**From:** Anja Jennings on behalf of Development Control (Dev Control)  
**Sent:** 27 June 2011 17:04  
**To:** Nicky Long  
**Subject:** FW: 11/96974 - Use as public house with wildlife & pub gardens (Use Class A4); shop front alterations; fenestration alterations to include rear doors & louvre; kitchen extraction; jumberella at 47-48 St. Thomas Street, Lyminster  
**Attachments:** 2011 March 31 Email from Rob Kirkaldy of Spectrum Acoustics.pdf

### Environmental Health (Pollution) Comments Relating to Noise and Odours

### **Additional Environmental Health (Pollution) Comments Relating to Noise and Odour**

**Lymington: St Thomas Street, St Thomas Park, Church Lane showing location of 90 dwellings (approx) within 100m (approx) of proposed site**

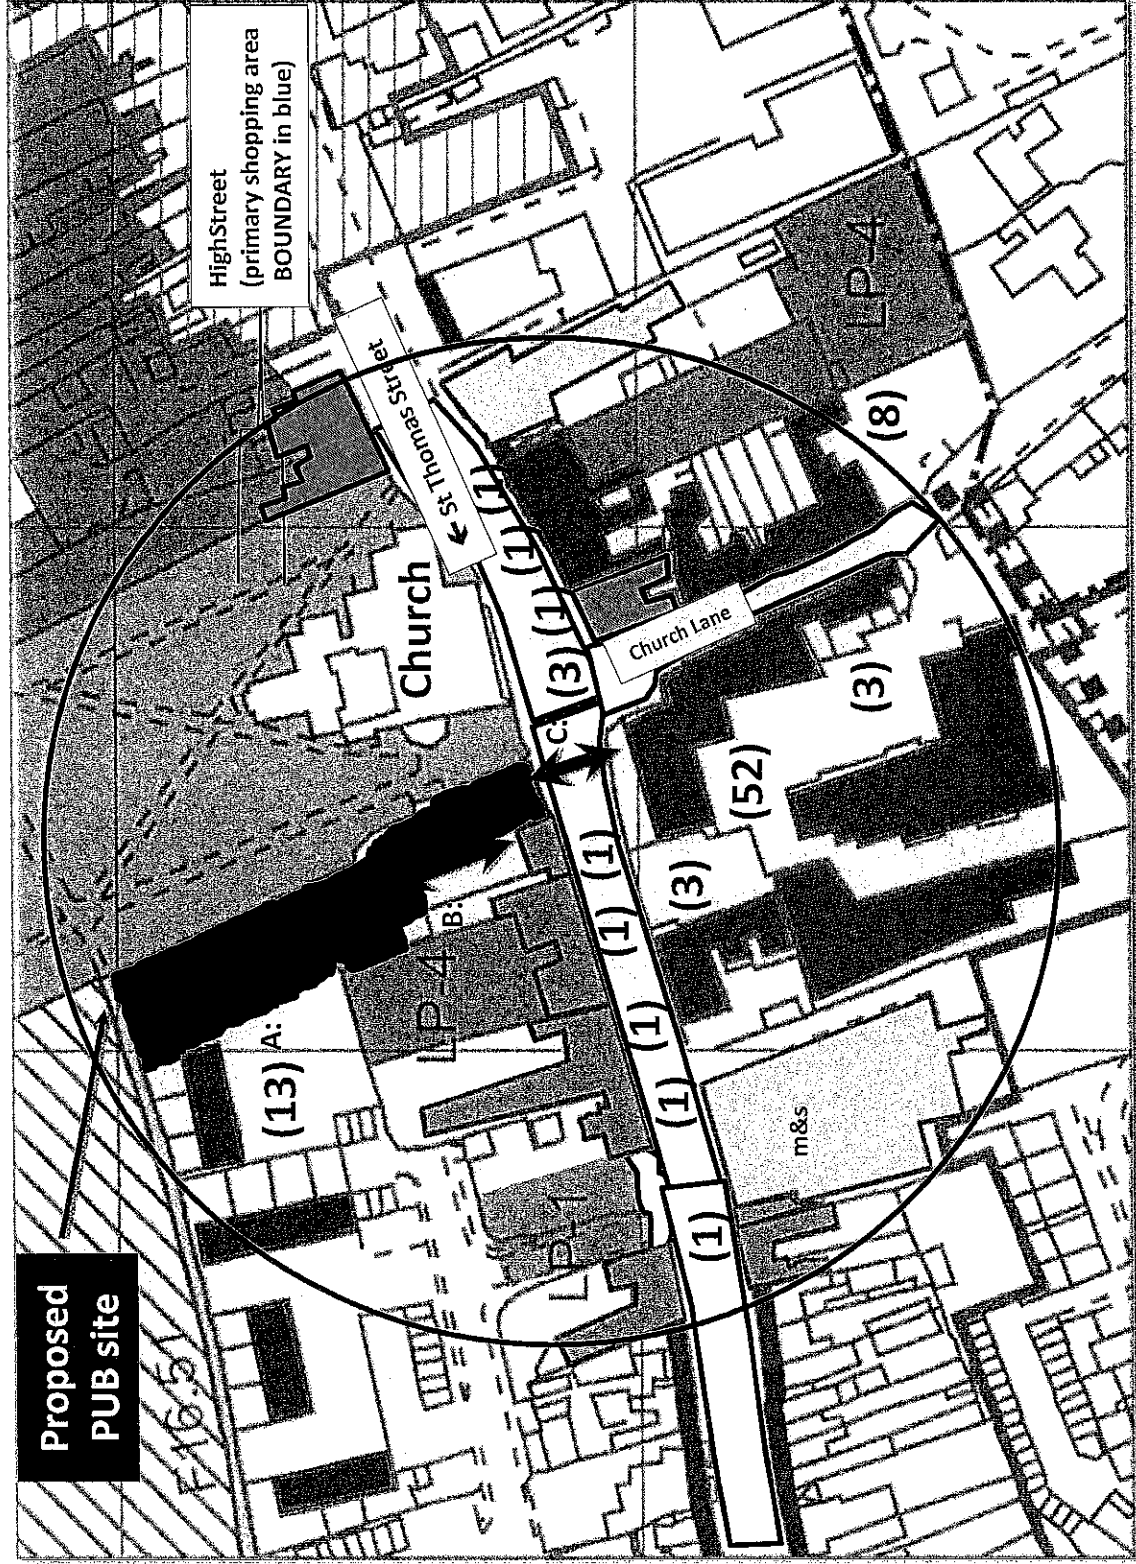
- Dwellings**  
(90) number dwellings
- Retail premises**
- Offices**
- Mixed residential and retail/surgery**
- ARROWS**  
A: 20m Beer garden to nearest house  
B: 25.3m Plant room to window  
C: 23.3m Proposed pub entrance to nearest care home bedroom window
- Circle is 100m radius from site frontage.**
- Properties highlighted in red, outside circle, are within 100m of the rear of site.**
